Dec. 18, 2021

RE: Technical memorandum on hydrologic and engineering assessment and CEQA documentation review- Head Royce School Planned Unit Development Permit Project, Oakland CA

Alida Court Map and Summary of Water Issues from Uphill

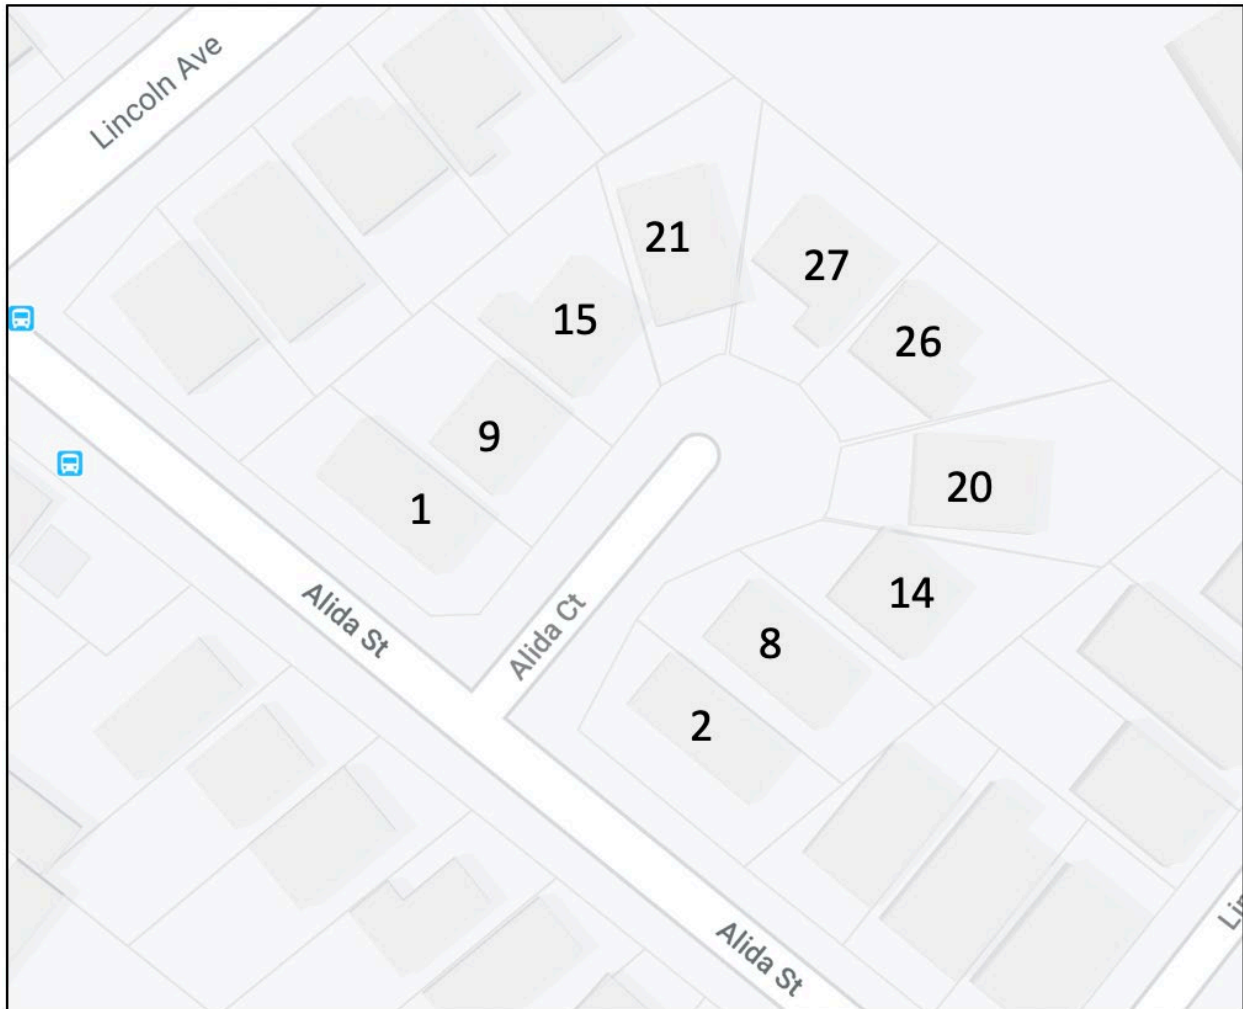
History of minor basement water intrusion during rainy season that we soak up with towels daily. Installed drainage in yard behind basement to mitigate. Continued to have minor problem through last winter and have been contemplating sump pump. No leaking this year so far. (We've only gotten about 6 of average 21 inches of rain so far this season, but since we bought house in 2012, there has been some leaking after the first series of storms until this winter.)

History of similar runoff from campus as 26 Alida Court issues (see below). Believe no active issues. House is not owner occupied – checking with owner to confirm status.

History of significant water runoff from campus behind house, that sluices down toward house and front of property. Initially, communications with Lincoln Child Center were initiated prior to July, 2013 following an incidence of a broken water pipe on the LLC property causing damage to recent landscaping on my property. The gravel and sandbags that were installed to remediate the problem proved insufficient during the heavy rains the following year. Large piles of gravel were pushed through my fence and deposited in my yard causing destruction to plants. Eventually, under HRS ownership and management, a “channel” and fence were built on the HRS property to divert the water with no further incidence.
